# The New Sydney Fish Market Modification 6

Temporary construction site accommodation  
State Significant Development Modification Assessment  
(SSD 8925 MOD 6)

March 2022

**Figure 4 | Proposed tree removal – T8** (source: Applicant's RTS)

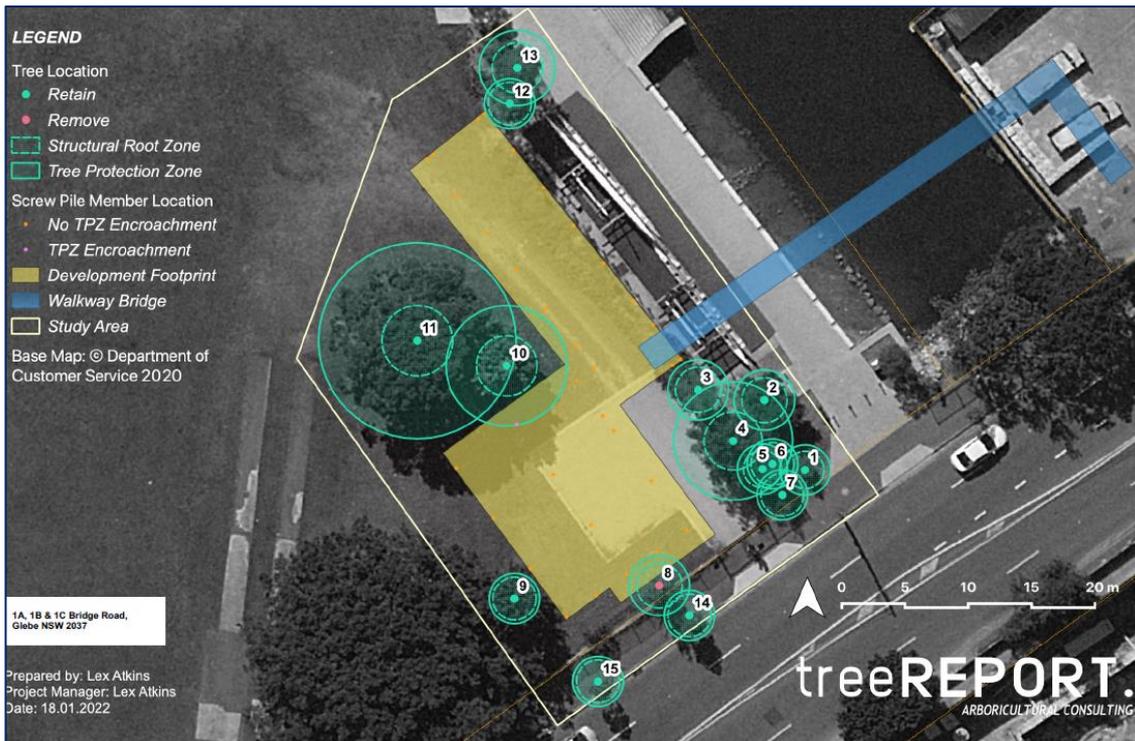
EESG raised no concerns with the tree removal and pruning works. However, Council raised concerns with:

- the proposed removal of tree T8 and recommended alternate methods for sewer connection is investigated
- the level of pruning to T4 and recommended the structures be setback further from the tree canopy to reduce the level of pruning

In response to the concerns raised, the Applicant submitted an amended arboriculture impact assessment (AIA) with the RtS and a further addendum letter to the AIA with the RRtS.

The Applicant justifies the proposed tree removal and pruning to tree T4 for the following reasons:

- tree T8 is an ornamental exotic species of cottonwood poplar and is of low landscape significance and low retention value
- offset replacement planting consisting of tree species which are endemic to the local area will be provided to compensate for the loss of tree T8
- a new sewer connection point to the existing sewer main in an alternate location would not be permitted by Sydney Water
- the pruning works to tree T4 are considered minor (with approximately 15% of the live canopy volume requiring removal).
- live crown ratios of 50% to 60% are required to maintain tree vitality while reducing the risk of premature limb/tree failure and the proposed removal of approximately 15% of the tree canopy is unlikely to have a significant long-term impact on the viability of tree T4.

The Department accepts the findings of the AIA and supports the removal of tree T8, as it is a non-native tree of low significance.

The Department considers the proposed pruning acceptable as it would not result in any significant long term harm to the trees as the amount of pruning is minor, accounting for no more than approximately 15% of the live canopy, which is well below the 50% to 60% threshold to maintain tree vitality.
